**Legislative Council Public Works Subcommittee
Meeting on 29 March 2019**

**780CL – Site formation and infrastructure works
for public housing development at Wang Chau, Yuen Long**

Supplementary Information

附圖一
 FIGURE 1

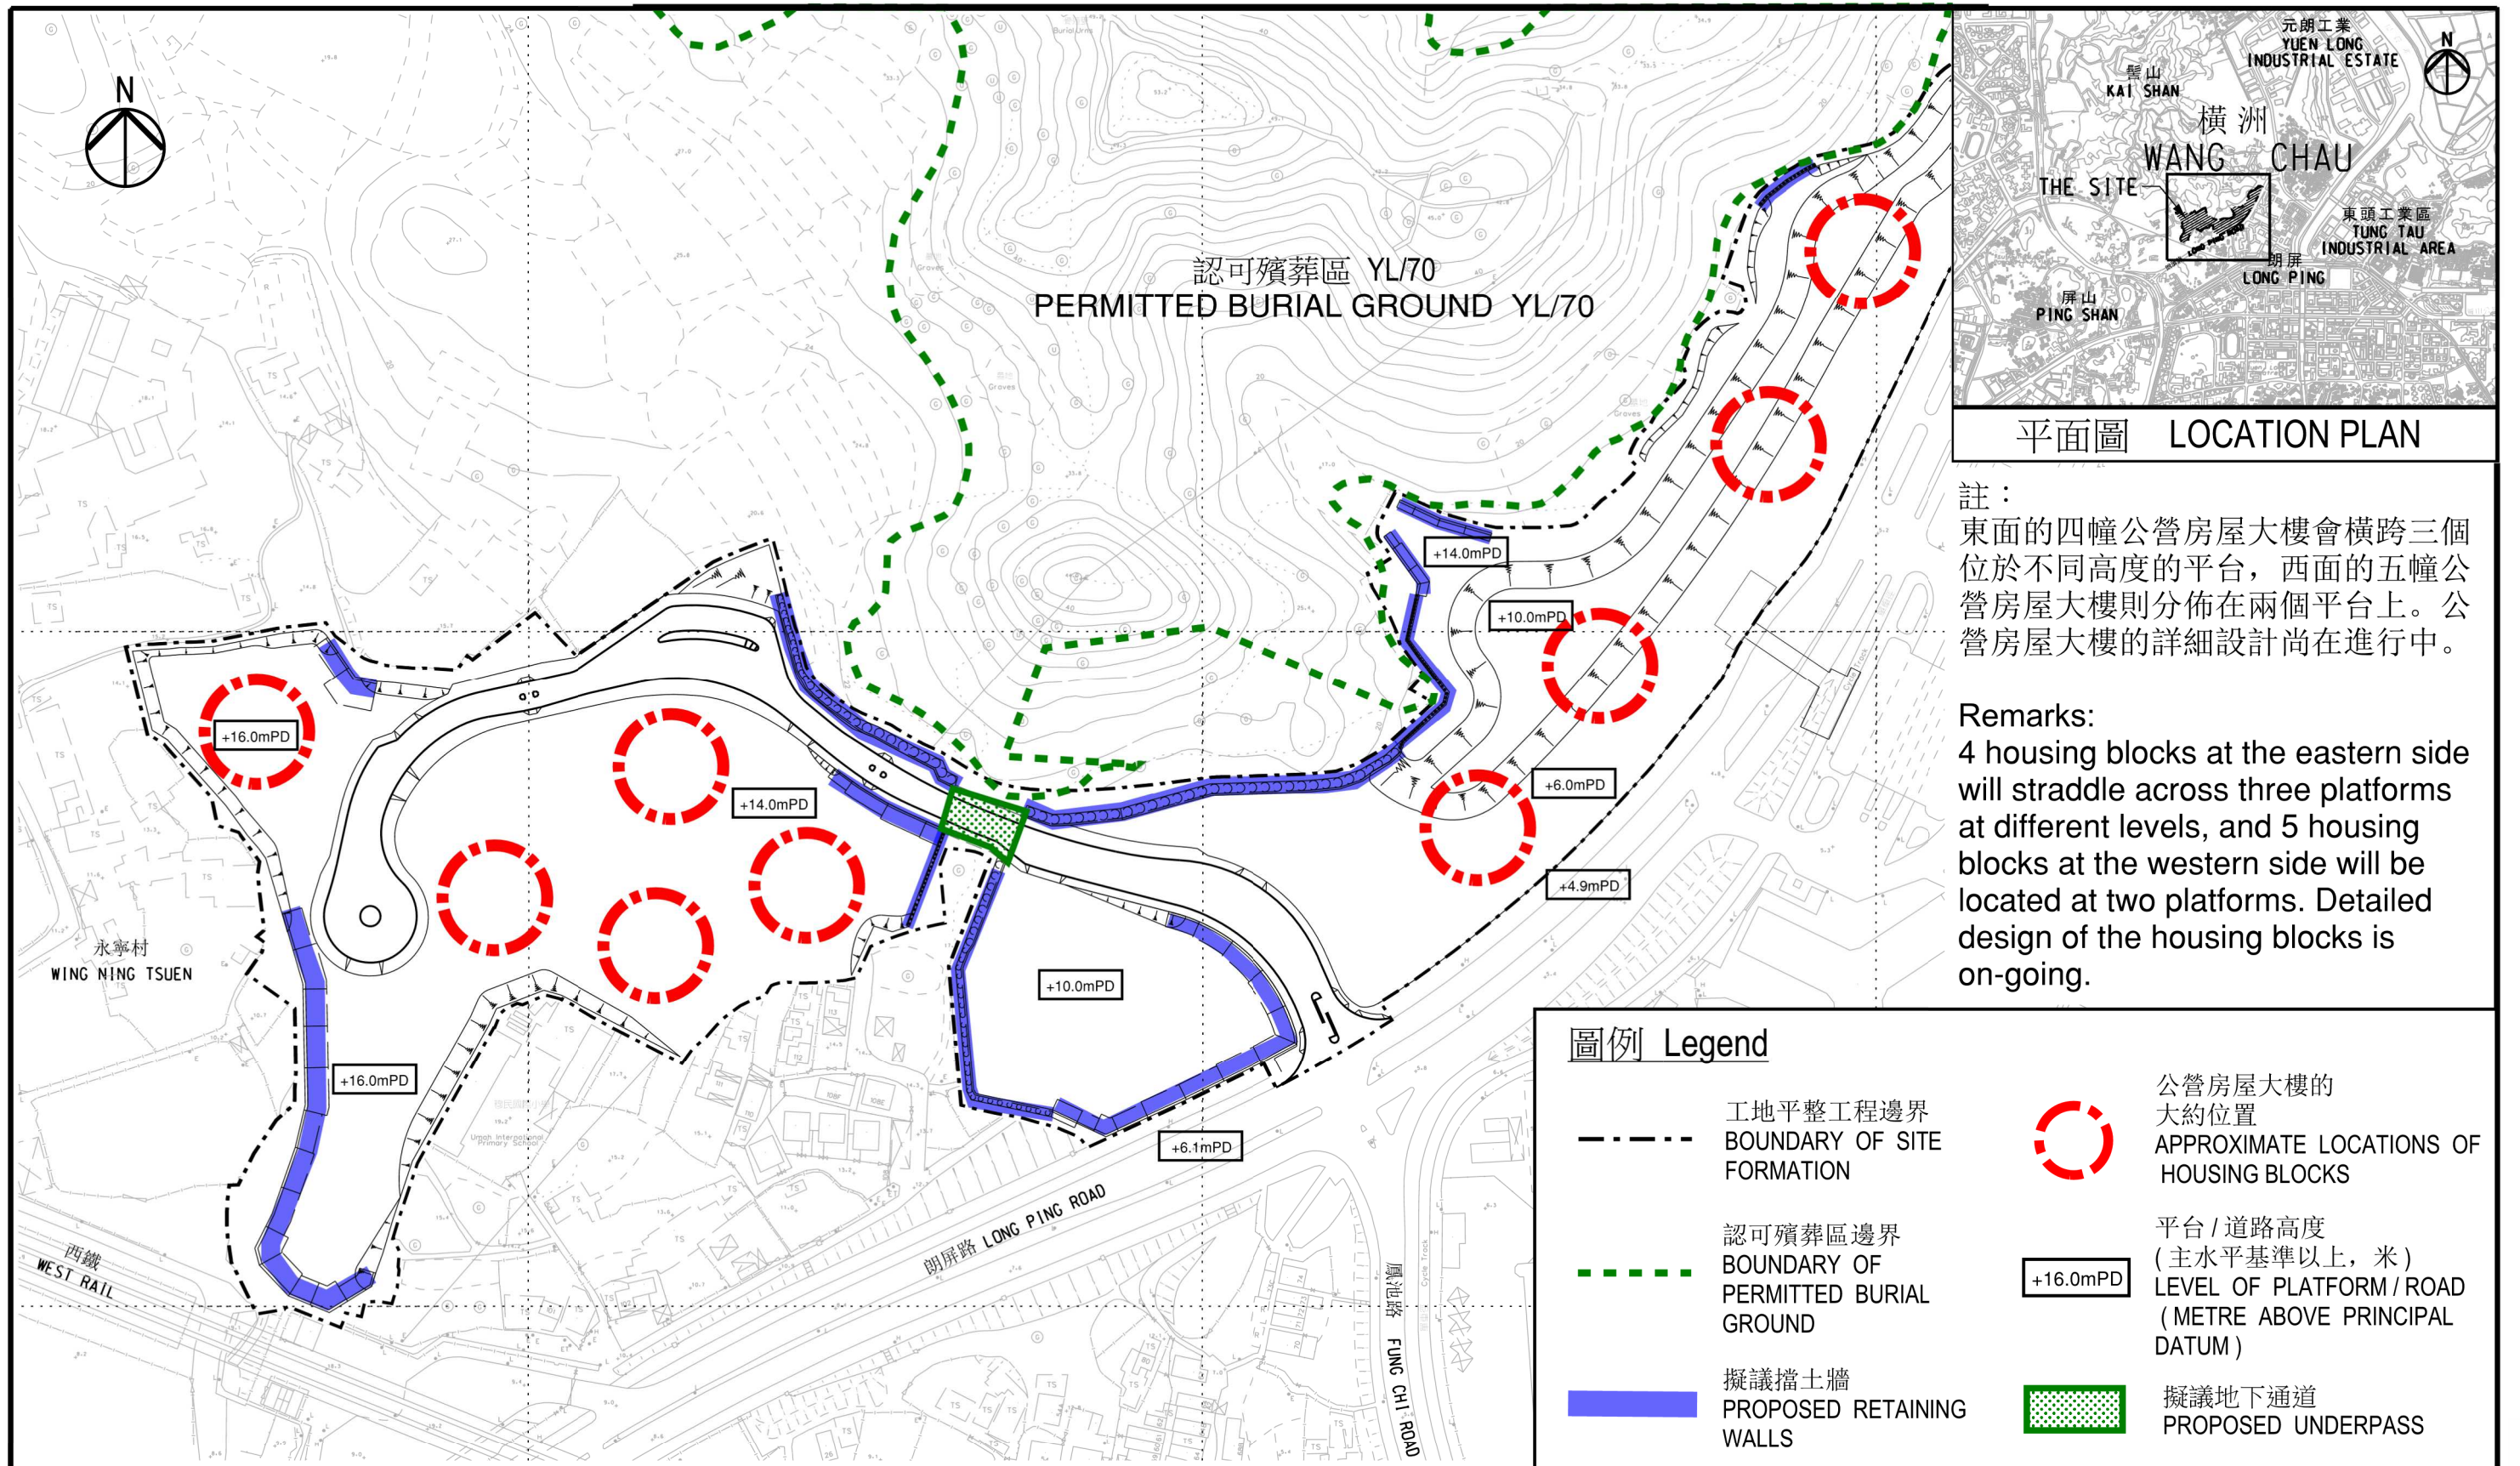
- (a) the number and distribution of public housing units to be constructed on the five platforms in the Wang Chau public housing development Phase 1, Yuen Long (WCPHD1);
- (b) the completion date of the report of the engineering feasibility study for site formation and infrastructure works for remaining phases (i.e. Phases 2 and 3) of public housing development at Wang Chau and the date of submission to the Legislative Council;
- (c) (i) in respect of the capital cost and phased expenditure of the proposed project mentioned in paragraphs 6 and 8 of the paper, the reduction in the estimated cost of the road works after review by the Project Cost Management Office of the Development Bureau; and
(ii) the reasons for requiring phased expenditure of project cost in 2024-25 and 2025-26.

- (a) The public housing development under WCPHD1 is now under the design stage. According to the current public housing design, the proposed public housing blocks under planning will be rested on platforms at different levels on the eastern and western sides. The four public housing blocks on the eastern side will straddle three stepped platforms at different levels, while those five public housing blocks on the western side will be rested on two site platforms.

Over 2 000 units will be constructed on the eastern side and nearly 2 000 units will be constructed on the western side, providing about 4 000 units in total. The approximate locations and distribution of the proposed public housing blocks are shown in Figure 1.

附圖二
FIGURE 2

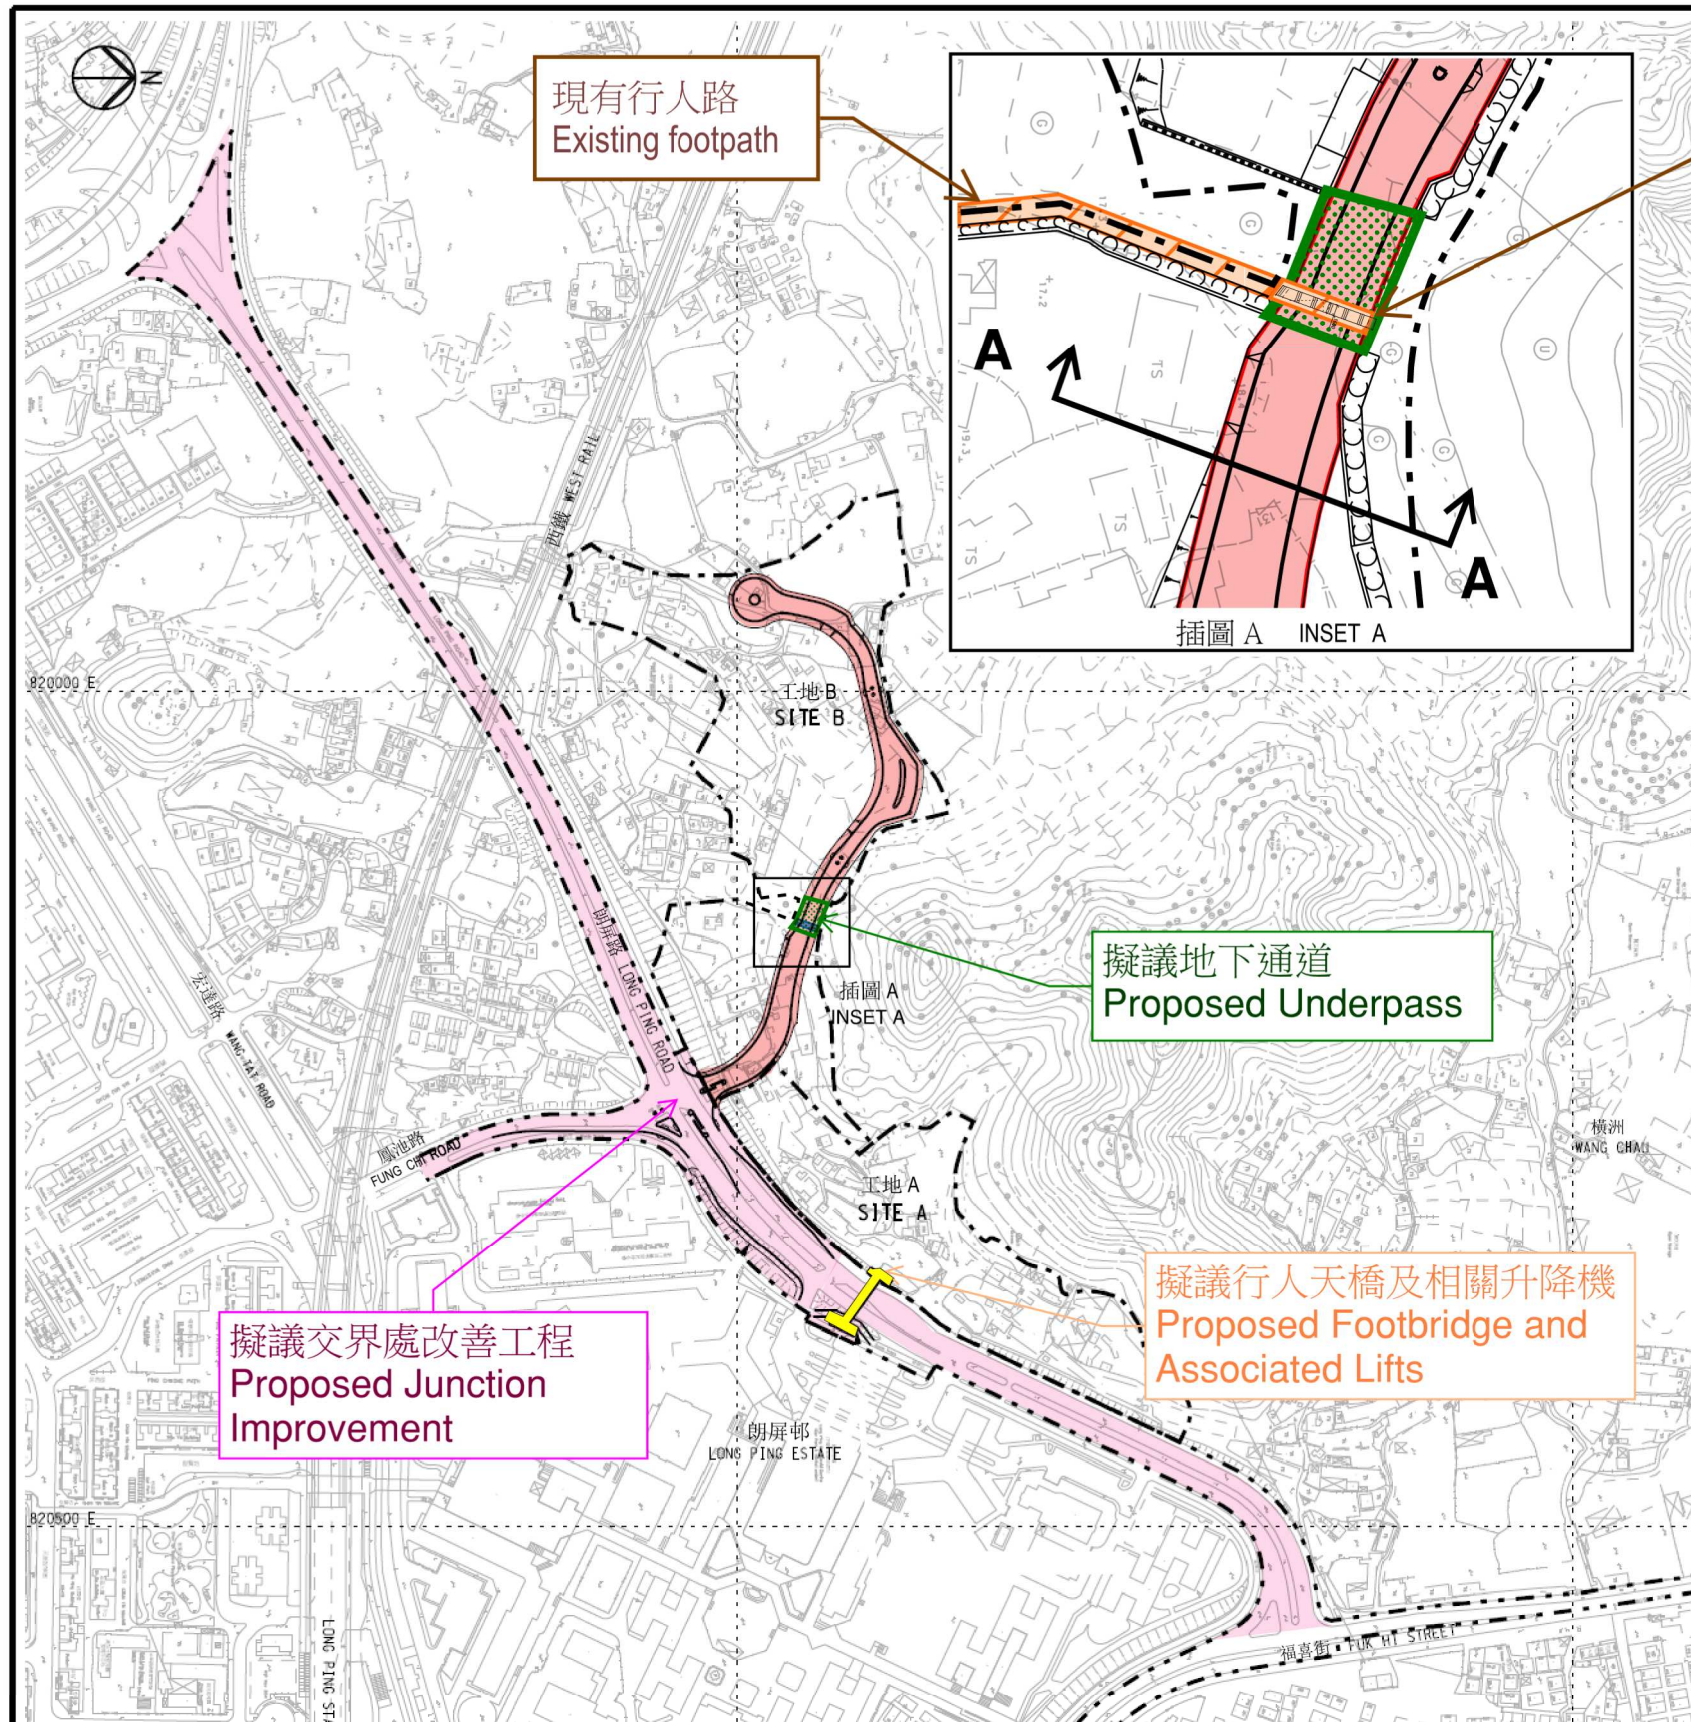
- (c)(i) The proposed “underpass” is an essential part of the proposed access road for the housing development. It is not purely providing access to the permitted burial ground. The “underpass” comprises a carriageway and footpaths. Its location plan and perspective drawing are shown in Figure 2. The cost of the footpath connected to the permitted burial ground and located above the proposed “underpass” only accounts for a very small amount of the estimated cost of the proposed underpass.

The project includes the construction of a single two-lane carriageway of about 400 metres (m) long with footpaths, connecting Long Ping Road to different platforms of the proposed public housing development. As the WCPHD1 will be built along hillside, site formation works are required and a number of site platforms

The proposed site platforms will be constructed at levels approximately between +6.0 metre above Principal Datum (mPD) and +16.0mPD. The proposed carriageway and footpaths will start at the proposed road junction with Long Ping Road at a level of about +5.5mPD and extend uphill to connect to various platforms. A section of the carriageway and footpaths will pass through the middle of an existing ancestral grave and the permitted burial ground (i.e. the location of the proposed “underpass”).

As gradient of carriageway has to comply with the design standards set out in the *Transport Planning and Design Manual*, the section of carriageway, i.e. at the location of the proposed “underpass”, has to be constructed at a level approximately between +10.4mPD and +10.9mPD. Since the existing ground level at that location is about +20.0mPD to +22.0mPD, the height difference between the existing ground level and the proposed carriageway will exceed 10m. Massive excavation is, therefore, required for the construction of the section of carriageway and footpaths there. Besides, due to site constraints, there is insufficient space for the construction of slopes on both sides of the proposed carriageway and footpaths. Vertical retaining structures must be constructed. The alignment of the road section and the design of the associated structures are also constrained by the ancestral grave and the permitted burial ground on the two sides of the proposed carriageway and footpaths. In order to maintain an existing footpath on the hill, it is necessary to construct a new footpath above the “underpass” to facilitate public access to the permitted burial ground. Having regard to different factors, we consider that the design of a box-type reinforced concrete vehicular tunnel should be most suitable and cost-effective for the construction of the said section of carriageway. Such design can provide space for the construction of the carriageway and the footpaths alongside as well as the footpath above the “underpass” for access to the permitted burial ground as proposed in the project.
